KANSAS GAS AND ELECTRIC COMPANY

July 25, 1984

KMLNRC 84-123
Re: Docket No. STN 50-482
Subj: Initial Test Program Changes

SNUPPS FSAR Section 14.2.3 addresses the availability of FSAR testing commitments for NRC review. In support of this section, transmitted herewith are marked-up changes to the Wolf Creek Initial Test Program described in the Wolf Creek and SNUPPS FSARs.

SNUPPS
TABLE 14.2 - 4 (Sheet 5)

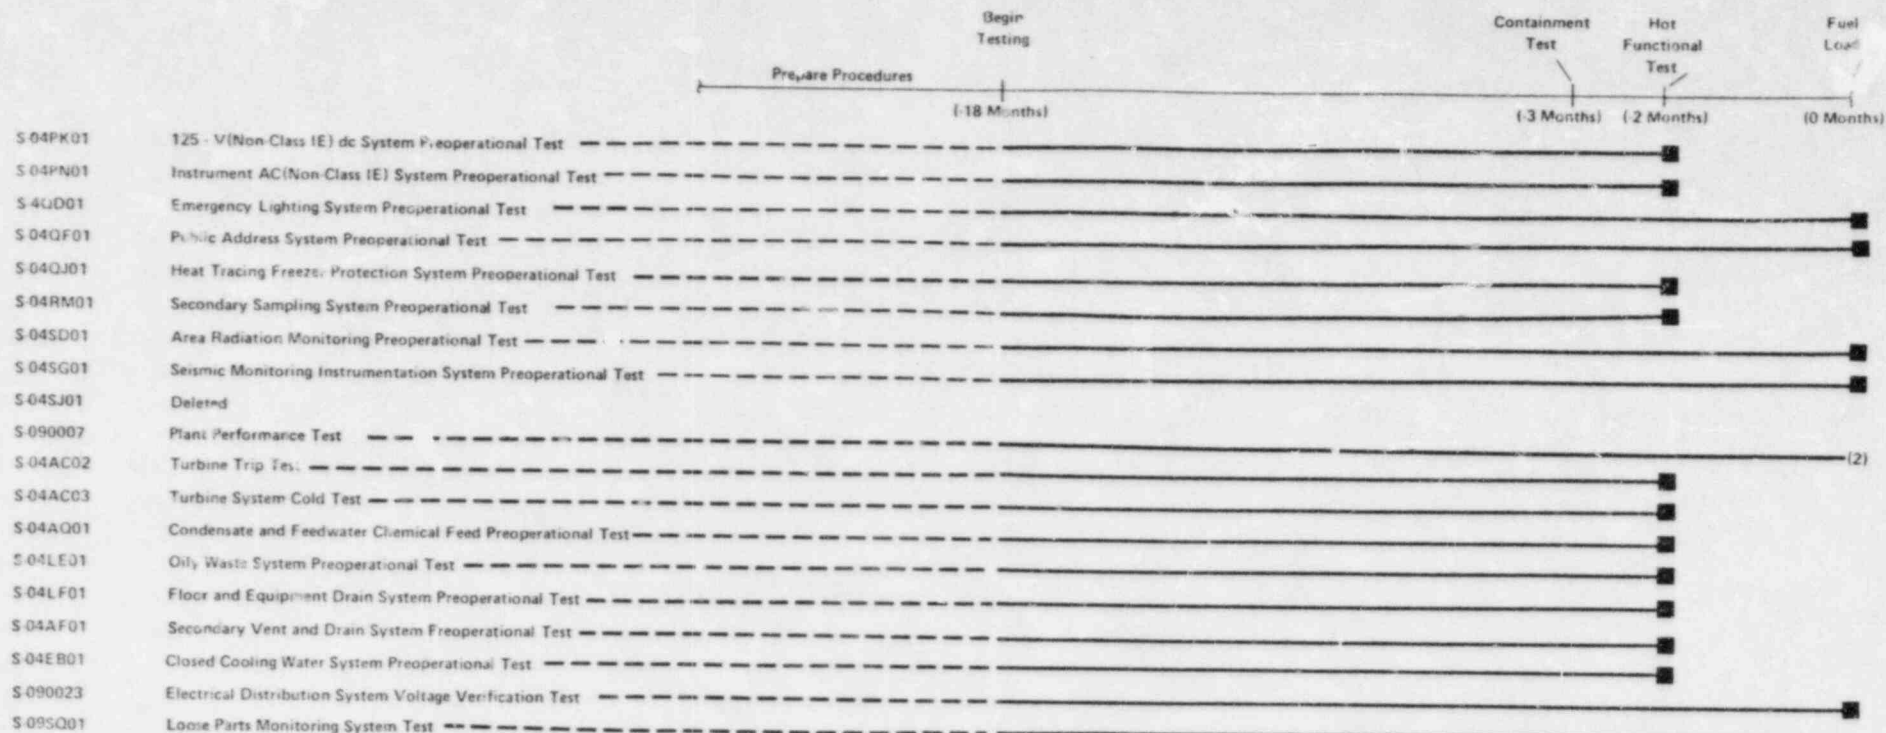
Preoperational testing is scheduled to commence approximately 18 months prior to fuel loading. The preoperational tests are performed and sequenced during this period as a function of system turnover, system interrelationships, and acceptance for testing ~~and are completed as identified on Table 14.2-4.~~

Preoperational tests which are not performed according to the Table 14.2-4 schedule are reviewed on a case-by-case basis. Administrative procedures are established to ensure that all prerequisites are met before testing is initiated. Upon completion of all prerequisite tests applicable to a system or subsystem, a documented review is conducted by Startup personnel to verify that appropriate documentation is available and that required prerequisite tests have been satisfactorily completed. All deficiencies which would prevent performance of preoperational tests or generate negative test results are identified and dispositioned prior to implementation of the preoperational tests.
